Sundry Print Report

Well Name: BILLIKEN 6 FEDERAL	Well Location: T26S / R35E / SEC 6 / SESW / 32.0658444 / -103.4107768	County or Parish/State: LEA / NM
Well Number: 2H	Type of Well: OIL WELL	Allottee or Tribe Name:
Lease Number: NMNM125401	Unit or CA Name:	Unit or CA Number:
US Well Number: 3002542686	Operator: DEVON ENERGY PRODUCTION COMPANY LP

Type of Action: Plug and Abandonment

WELLBORE DIAGRAM - PROPOSED

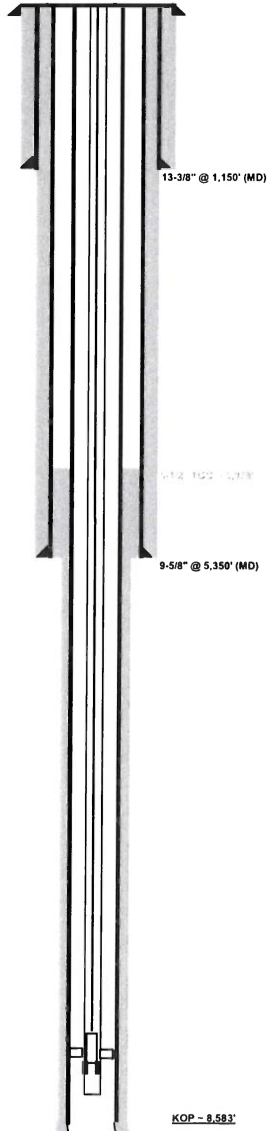
REVISED
8:02 am, Mar 28, 2026

*Run CBL from CIBP to surface.
Submit results to BLM.
